RE: Engineering Comments
Vessel Multi-family Housing
Site Plan Application
446 Hopmeadow Street
Simsbury, CT 06070

H+H Engineering Associates, LLC (H+H) is in receipt of the Town of Simsbury Engineering Department review comments dated January 27, 2023 regarding the Vessel Multi-family Housing Site Plan Application located at 446 Hopmeadow Street in Simsbury, CT 06070.

Below please find the original review comment, followed by our response in bold:

LRFD FILL HEIGHT TABLES

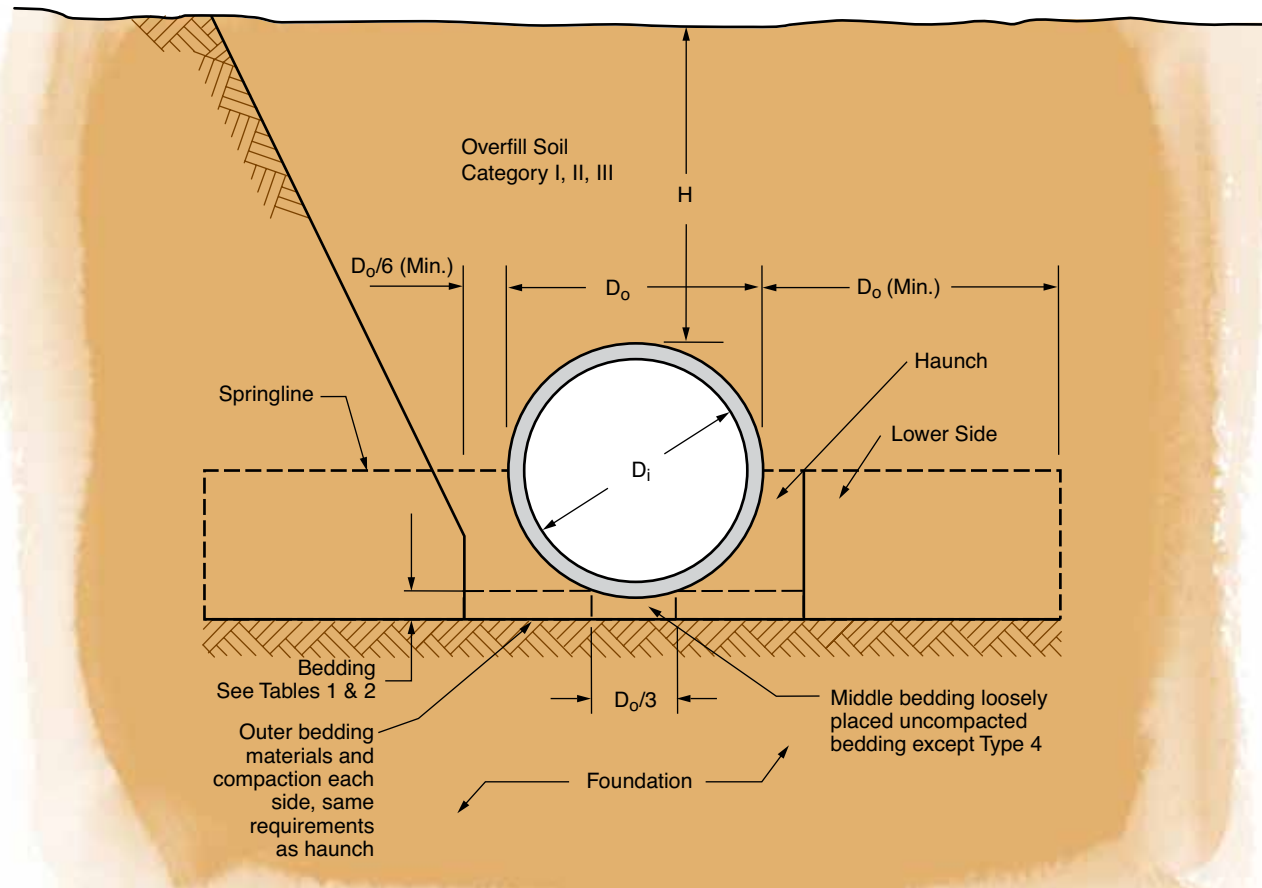
5. CB-5 has 2-feet of cover whereas Section 5 .2.1.g of the Town of Simsbury Highway Construction and Design Standards states "A minimum cover of 2.5 feet shall be provided for all drain pipes unless special designs, as approved by the Town Engineer, are utilized." Please revise accordingly.

As noted, the minimum cover over the drainage pipe exiting CB-5 is approximately 2-feet at the catch basin, which increases to 2.5-feet approximately 10-feet from the catch basin. Additionally, the pipe material has been identified as Class IV RCP, which is suitable for less than 24" of cover (see attached LRFD fill height table for RCP).
